Re: Status Update and Site Investigation Work Plan Adjustments Municipal Wells 23 & 24, La Crosse, WI, WDNR BRRTS # 02-32-000065

June 17, 2020 CORRECTION: Site Investigation Work Plan Municipal Wells 23 & 24, La Crosse, WI WDNR BRRTS # 02-32-000065

Figure 8: 2001 Crash Site

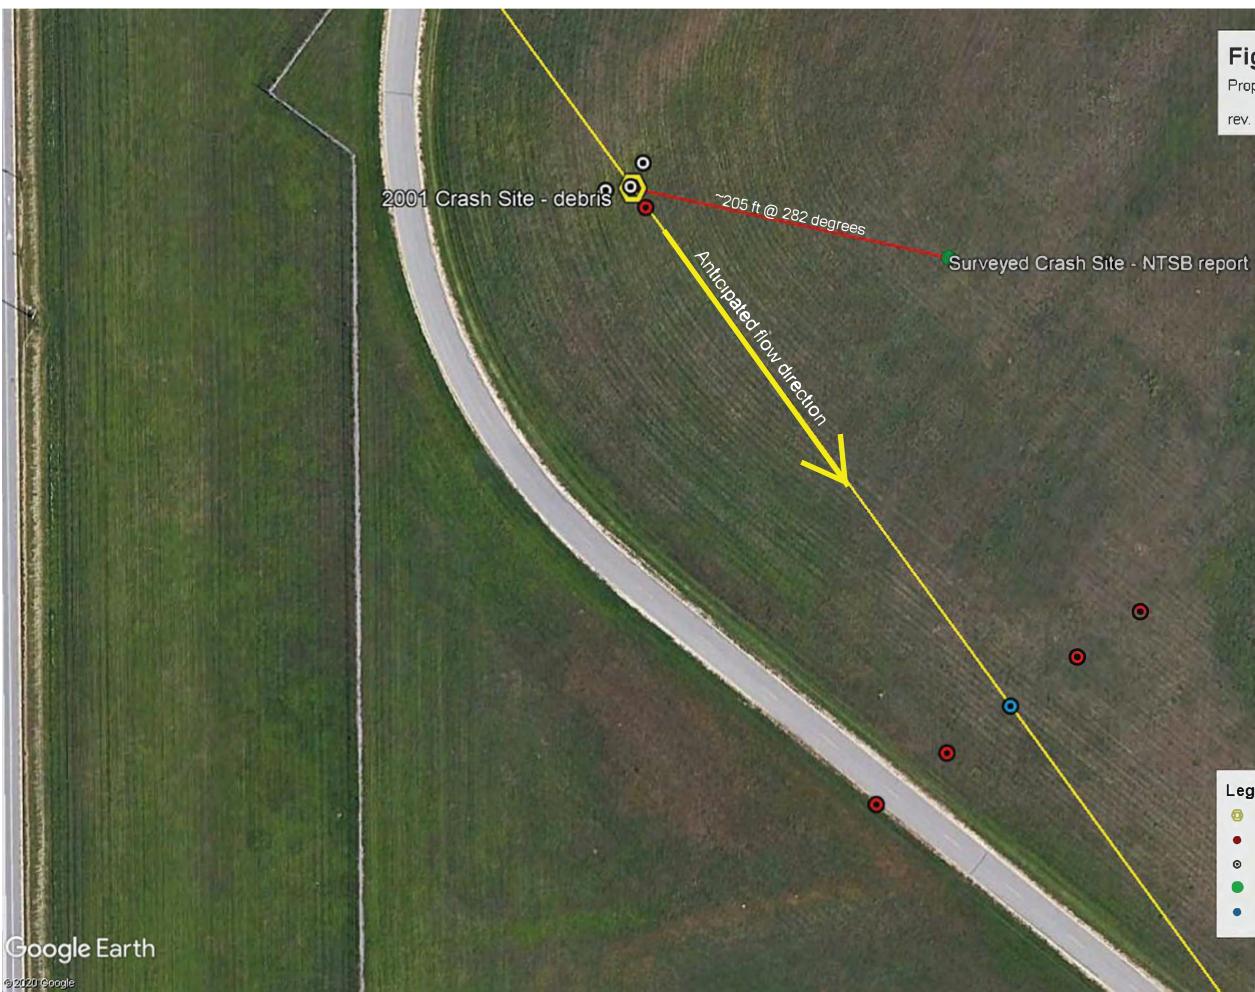
The attached figure 8 depicts our revised soil boring and monitoring well locations at the 2001 Crash Site. We have not only translated the locations laterally, but we have also tightened the spacing of the down-gradient row of borings because the location of AFFF application is now better defined. Copies of selected photographs of the crash scene are also attached. Note that certain photos with landmarks that we used to pinpoint the crash site are not included because they depict human remains. Out of respect for the deceased and their families, we do not feel it is appropriate or necessary for those photos to be part of the public record.

Thank you for the revised site investigation work plan. I appreciate your timely updates. The revisions are approved and I look forward to continued progress at this site.
